Access Compliance Report

Public Rights-of-Way

(Curb Ramps)

| Intersection ID: N/A | Main Street: E_ARROWWOOD_RD | Cross Street: N/A | Location: S |

| ADA ID: 49AB2C30554F | Ramp Type: Perp | Initial Pass/Fail: Fail | Overall Compliance: No |

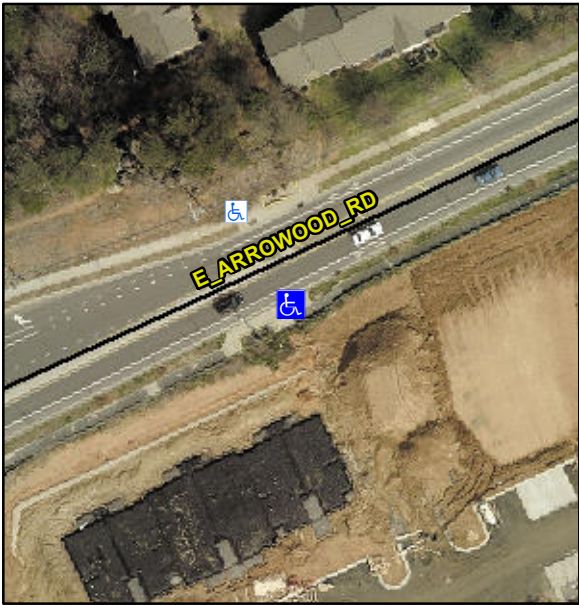
| Codes/Mitigation Info/Possible Solution | | | Field Measurements/Component Compliance | | | | | |
|--|-------------------------------|-------------------------------|---|-----------------------|------|------------|-----------------------------|------|
| | Remove & Replace Entire Ramp. | | N/A | Ramp Length (in) | 72.0 | No | Ramp Slope (%) | 8.9 |
| | | | Yes | Ramp Width (in) | 60.0 | No | Ramp XSlope (%) | 7.8 |
| PROW/ADA: | | Not Found, R304.2.2, R304.5.3 | N/A | Shared Landing? | N/A | | | |
